SECTION 82A REVIEW APPLICATION ASSESSMENT REPORT

1156 Pittwater Road, Collaroy

Proposal: S82A Application to review DA2008/0177 for partial

Development Application No: REV2008/0026

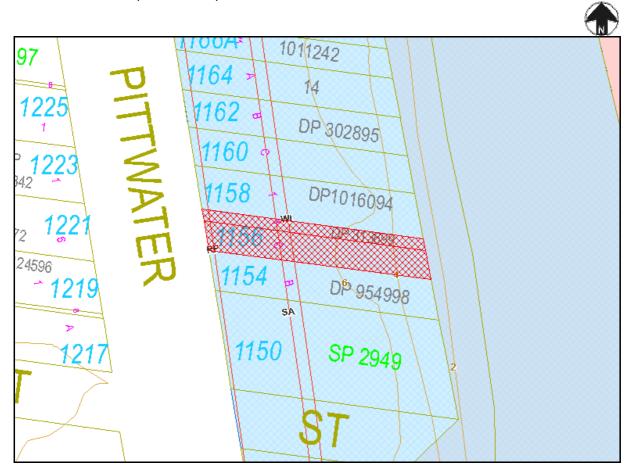
With specific regard to the existing structure within the wave impact zone, the proposed pitched roof is in place of an existing partially flat and partially pitched roof. See below the information provided by the applicant dated 2 February 2009. Pursuant to Schedule 1 of the WLEP 2000- Exempt Development, a change in building materials is exempt development, but a change in roof pitch is not and accordingly is not a minor development.

The roof area covered by areas 1 + 2 within the Wave Impact Zone is approx 11m2 and the roof for area 3 is approx 6½m2. Thus, the actual change of roof pitch applies to less than 38% of the total (and small) area in question. The proposed change in materials used in area 1 which is currently tiled, to a lightweight steel roof at the same pitch as the rest, would ensure that the overall structural weight of the area is improved."

Catchment Management Unit has reviewed the supplementary report and advised that the report satisfactorily addresses the unit's concern and there is no further objection.
